15B Failure Modes and Effects Analysis (FMEA)

The information in this appendix of the reference ABWR DCD, including all subsections, tables, and figures, is incorporated by reference with the following departures.

Figure 15B-1 Simplified CRD System Process Flow Diagram

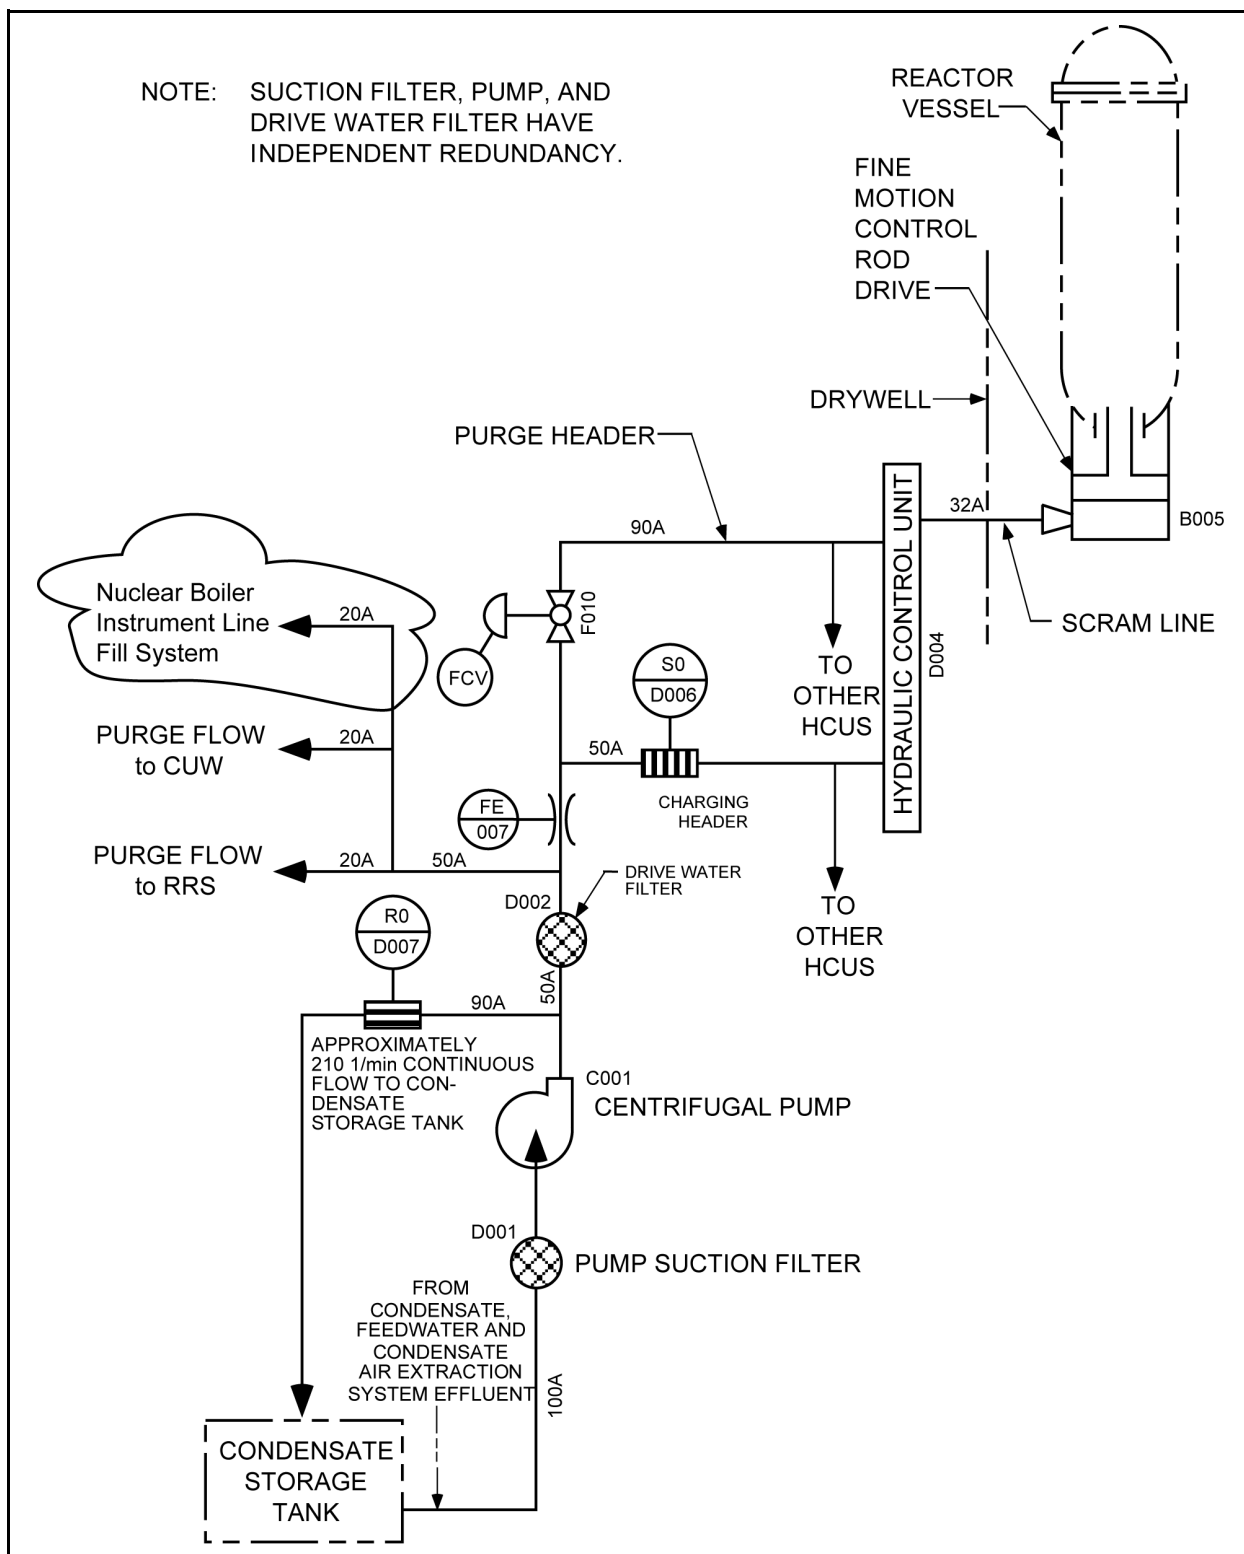
STD DEP 7.7-1 (Figure 15B-1)

STD DEP 7.7-1

A simplified CRD System process flow diagram is shown in Figure 15B-1. CRD System water is taken from the condensate, feedwater and condensate air extraction system, or Condensate Storage Tank (CST) through a suction filter by a centrifugal pump and discharged through a drive water filter to the HCU's. (During shutdown the CST is the primary source.) Each of these components is independently redundant and only one of each is in operation at any one time. A portion of the pump discharge flow is diverted through a minimum flow bypass line to the CST. The pumped water is directed to the HCU to provide hydraulic scram and to furnish purging to the drive. This system also provides purge water for the reactor internal pumps, nuclear boiler instrument lines, and the reactor water cleanup pumps.
